A303 Sparkford to Ilchester Dualling Scheme TR010036

8.3 Statement of Common Ground with Historic England

DRAFT STATEMENT OF COMMON GROUND

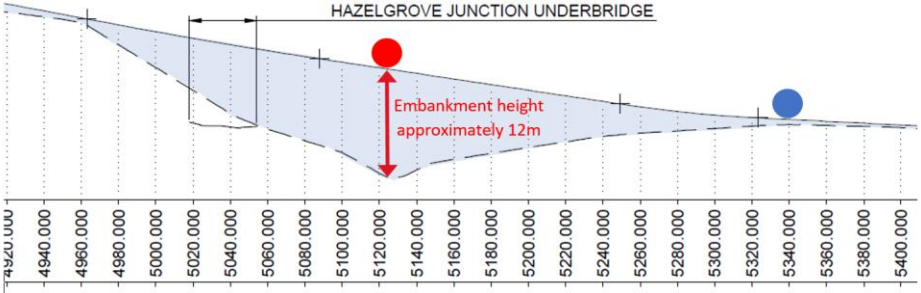
<p>CS provided an overview of the anticipated heights of the new junction layout at Hazlegrove RPG, using the below images to aid the discussion.</p> <p>SM asked to see cross sections to show the slope profiles from the Hazlegrove House key view. CS confirmed that the design team could develop these and issue for information shortly.</p>	CS / OM to develop
